Land known as Bull Field, Warish Hall Farm Consultation Response Document

Proposed Residential Development - Bull Field, Takeley - Transport Assessment Addendum
Rev 1 (Dated: 28/09/2023)..

Transport Assessment Addendum

Weston Homes

Project:	Takeley
Title:	Parsonage Road Access
Client:	Weston Homes
Drawing Status:	
Scale:	1:1000 (0 A3) Date: 24/09/2021
Drawn:	CM Checked: JK Approved: JK
Drawing:	2007045-SK-11 A

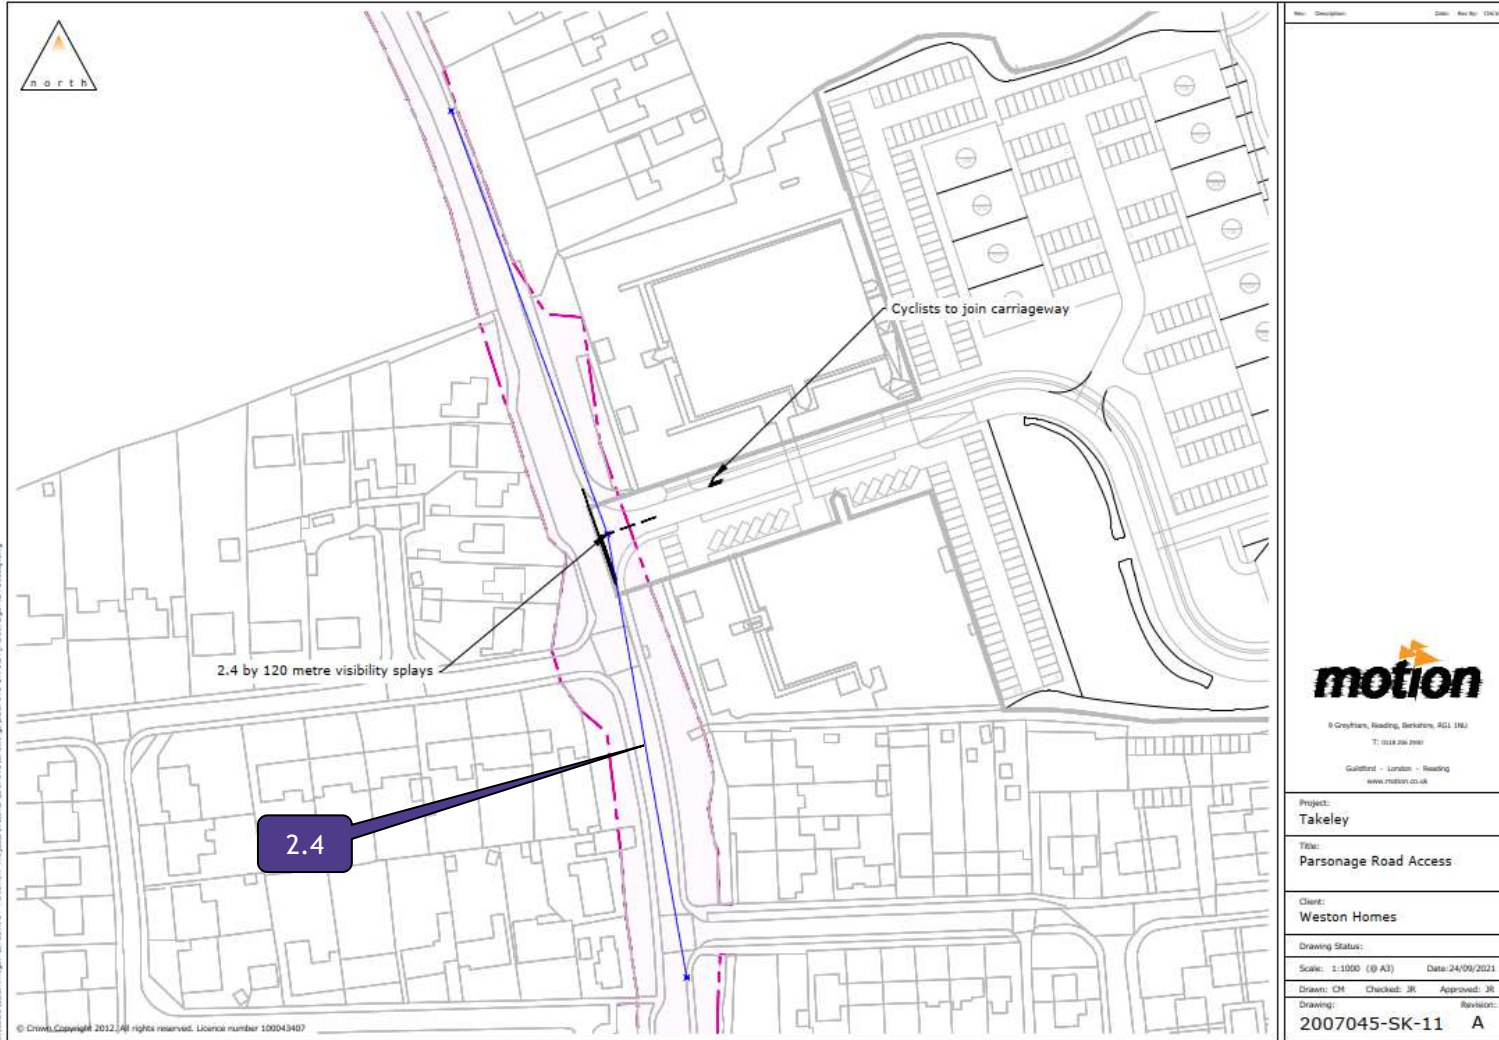
Provide a crossing facility to assist pedestrians in reaching the northbound bus stop, 120 metres south of the site access on the west side of Parsonage Road.

RSA Decision Log				
Item No.	RSA Recommendation	Design Organisation Response	Overseeing Organisation Response	Agreed RSA Action
2.4	Provide a crossing facility to assist pedestrians in reaching the northbound bus stop, 120 metres south of the site access on the west side of Parsonage Road.	Accepted, a contribution towards a pedestrian crossing has been agreed to provide access across Parsonage Road.

Project:	Warish Hall Farm, Takeley
Title:	Active Travel Network
Client:	Weston Homes Plc
Drawing Status:	
Scale:	1:5,000 (@ A3)
Date:	27/09/23
Drawn:	DR
Checked:	MF
Approved:	MF
Drawing:	2007045-02
Revision:	A

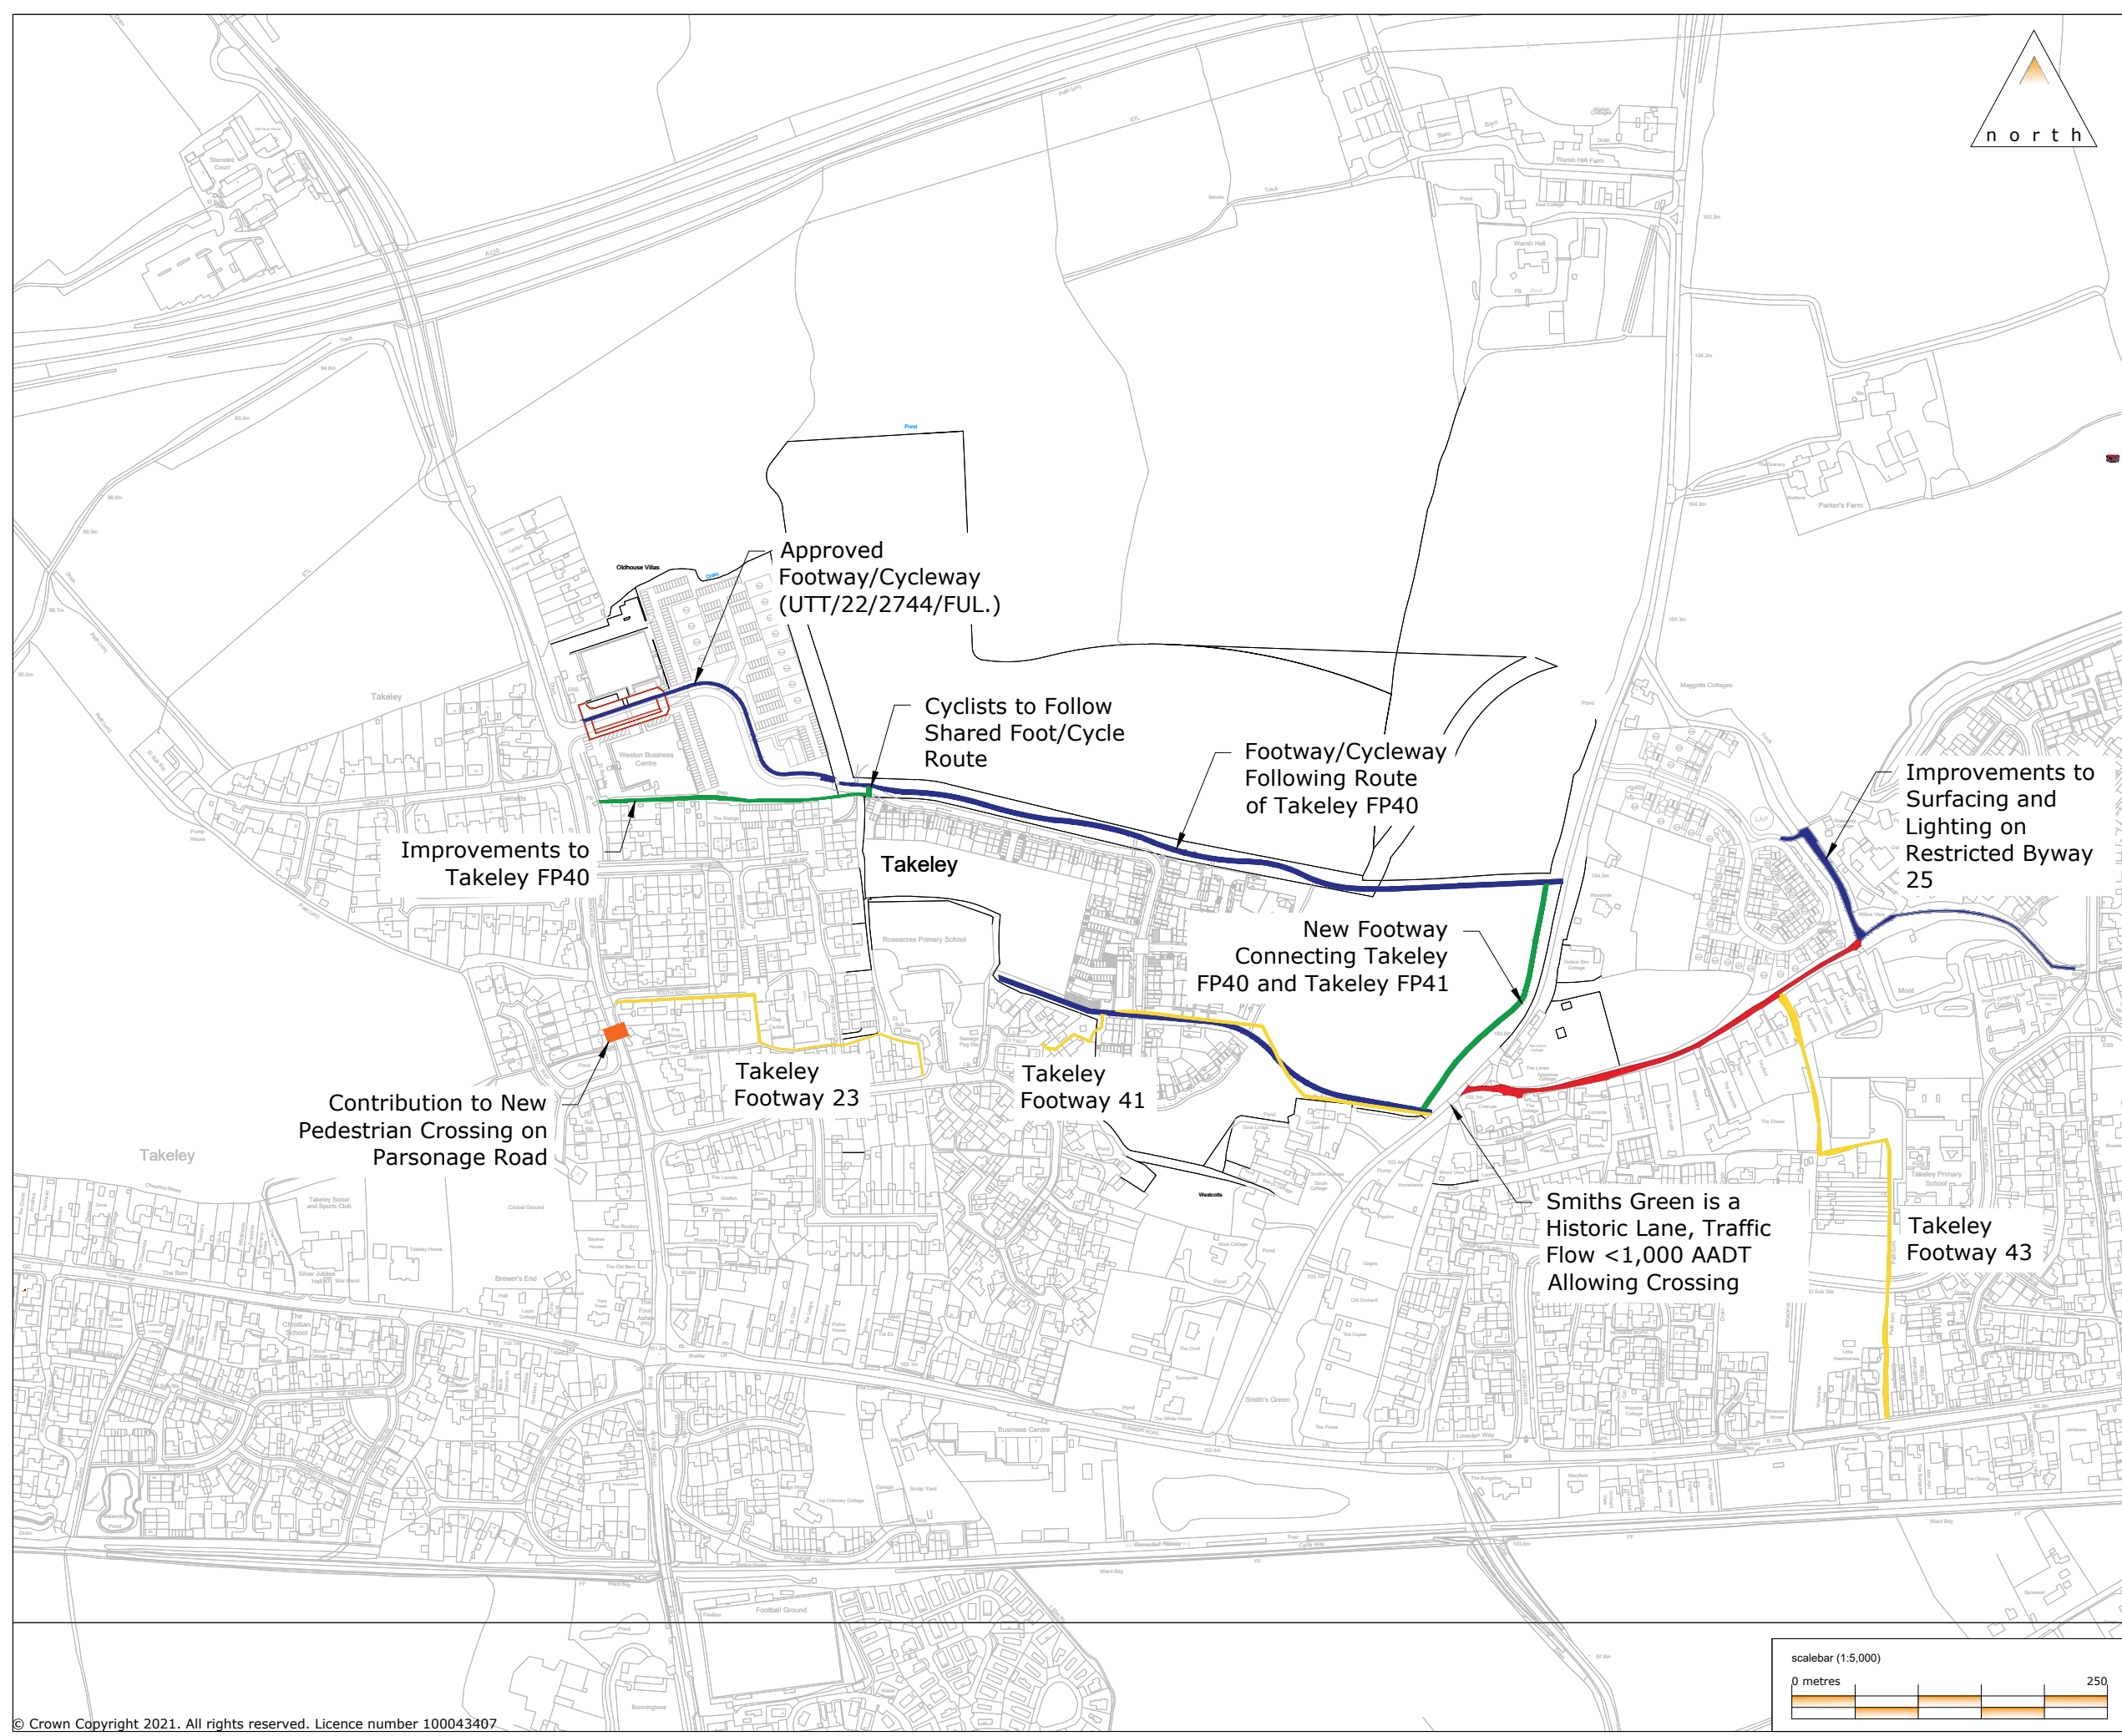
- 3.4 A plan (Dwg. No. 2007045-02A) illustrating that these three application sites have been designed in order to provide an integrated active travel network is provided at **Appendix E**. This illustrates the following provision:

- 3.6 The Applicant is willing to accept a suitably worded condition or obligation to ensure that all the works shown on the plan provided at **Appendix E** are delivered as part of this Planning Application in the event that either the delivery of the 7 Acrea Application permitted works stalls or else the planning application for Jacks Field (current live application UTT/22/3126/FUL) fails.
